# Access Compliance Report

## Public Rights-of-Way

Intersection ID: 5162	Main Street: BROOKFIELD_POINTE_DR	Cross Street: SUNSET_RD	Location: E
ADA ID: E5BF4D7CBDC7	Ramp Type: Perp	Initial Pass/Fail: Fail	Overall Compliance: No
Severity Score: 33.75			
Codes/Mitigation Info/Possible Solution		Field Measurements/Component Compliance

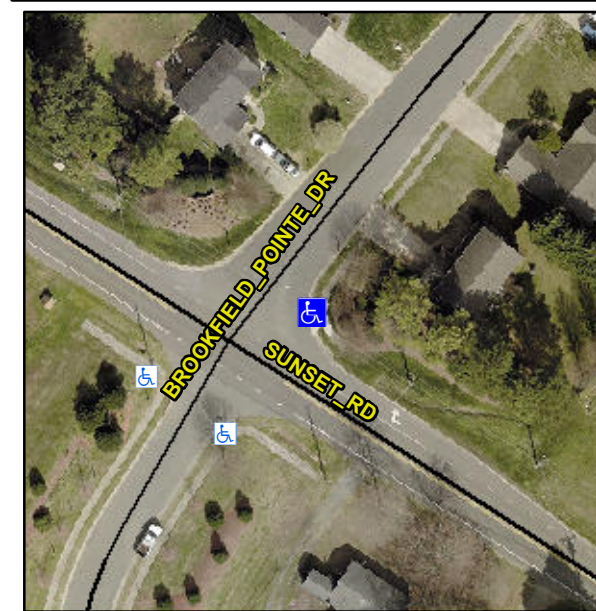
**Not Found, R304.5.1, R304.2.2**

Compliance	Description	Data	Compliance	Description	Data
N/A	Ramp Length (in)	84.5	No	Ramp Slope (%)	13.7
No	Ramp Width (in)	44.0	Yes	Ramp XSlope (%)	0.9
N/A	Flare Type LT	N/A	N/A	Flare Type RT	N/A
N/A	Flare Slope LT (%)	N/A	N/A	Flare Slope RT (%)	N/A
N/A	Flare Traversable LT?	N/A	N/A	Flare Traversable RT?	N/A
N/A	Landing Length (in)	N/A	N/A	DWS Provided?	N/A
N/A	Landing Width (in)	N/A	N/A	DWS Contrast?	N/A
N/A	Landing Slope (%)	N/A	N/A	DWS Length (in)	N/A
N/A	Landing X Slope (%)	N/A	N/A	DWS Full Width?	N/A
N/A	Landing Curb? (Y/N)	N/A	N/A	DWS Offset (in)	N/A
N/A	Shared Landing?	N/A			
N/A	Gutter Ponding?	N/A	N/A	Gutter Slope (%)	N/A
N/A	Gutter Lip Ht (in)	N/A	N/A	Gutter X Slope (%)	N/A
N/A	Painted X Walk1?	No	N/A	Painted X Walk2?	N/A
	X Walk 1 Direction	To SW		X Walk 2 Direction	N/A
N/A	X Walk 1 Width (in)	N/A	N/A	X Walk 2 Width (in)	N/A
	X Walk 1 Slope (%)	2.1		X Walk 2 Slope (%)	N/A
	X Walk 1 X Slope (%)	2.3		X Walk 2 X Slope (%)	N/A

**Remove & Replace Entire Ramp.**
